Service Bulletin No. 066

Gear Driven Alternator Rotor Replacement HET Models ALX-9522, ALX-9524, & ALT-9522

Figure 1 - Typical Rotor Assembly
(ALH-2238S-1, ALU-2238S-1, or ALX-2238AS-1)

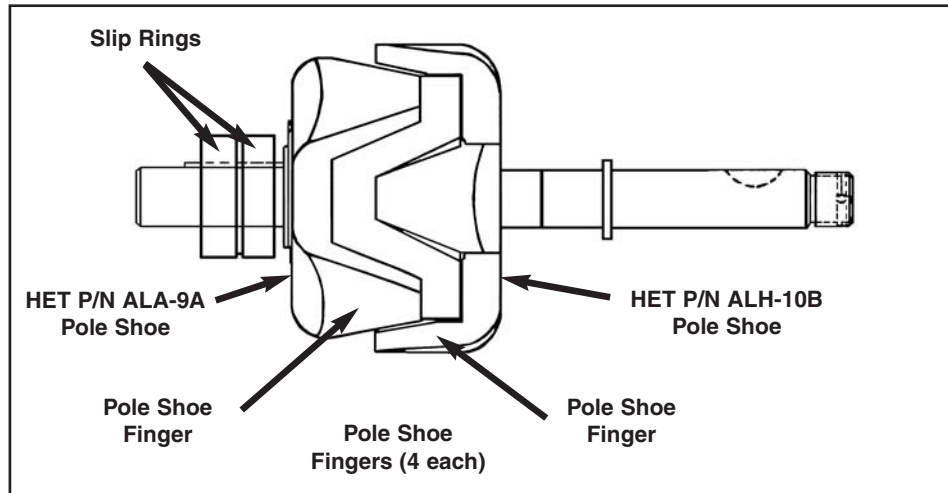
- (1) The suspect serial numbers of alternator models ALT-9522, ALX-9522, and ALX-9524 have rotor assemblies that contain pole shoes ALA-9A and ALH-10B that may fracture during normal operation.
- (2) Fracture of the pole piece fingers may result in rotor seizure. Refer to Fig. 1.
- (3) Regulatory action is unknown.

- (1) This Service Bulletin provides Instructions for Continued Airworthiness (ICA).
- (2) This Service Bulletin requires factory inspection/repair or field replacement of suspect rotors in affected alternators.
- (3) This Service Bulletin requires factory inspection/replacement of suspect piece part rotors.

**Figure 2 - Suspect Rotor Identification,
Date Codes - 35 14 through 18 16 (week, year format)**

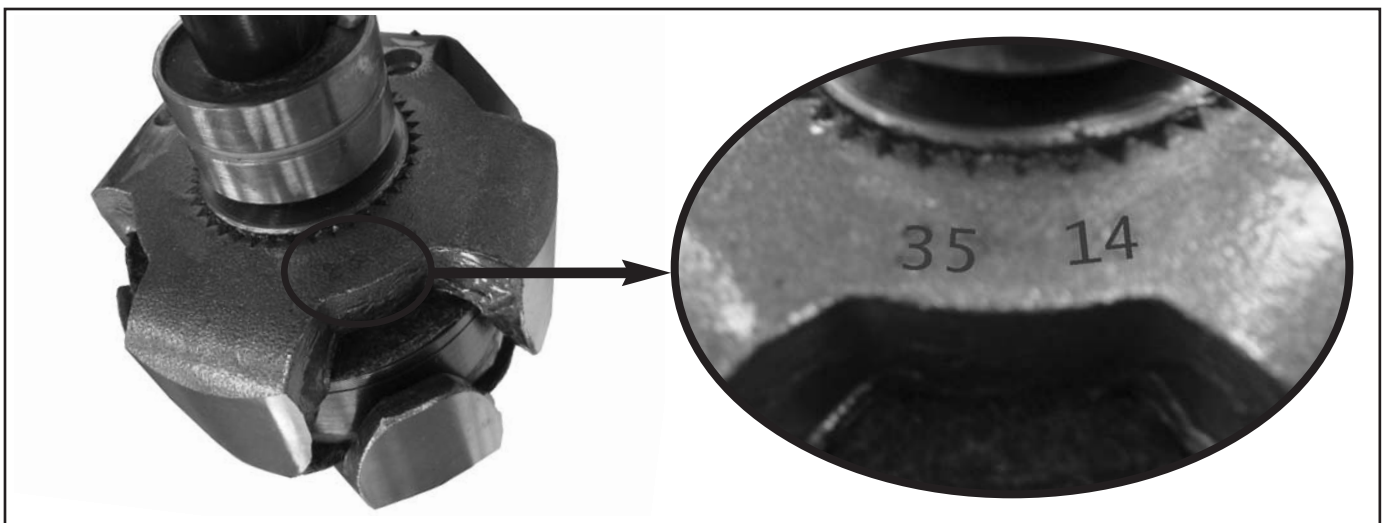
- A. ALX-9522, ALX-9524, and ALT-9522 alternators with serial numbers listed in Table 1.
- B. Rotors and kits with date code stamp 35 14 through 18 16 (week, year format) or that were delivered between September, 2014 through May, 2016.
 - (1) Includes alternators documented to contain affected rotors through field overhaul or repair.

NOTE: Suspect rotors may be returned to the HET factory for inspection to determine if the rotor is affected. Suspect rotors not inspected by HET are considered affected. Factory inspected rotors in the date code range listed in 1.A(2) Effectivity that are not affected will have an "X" stamped after the date code.
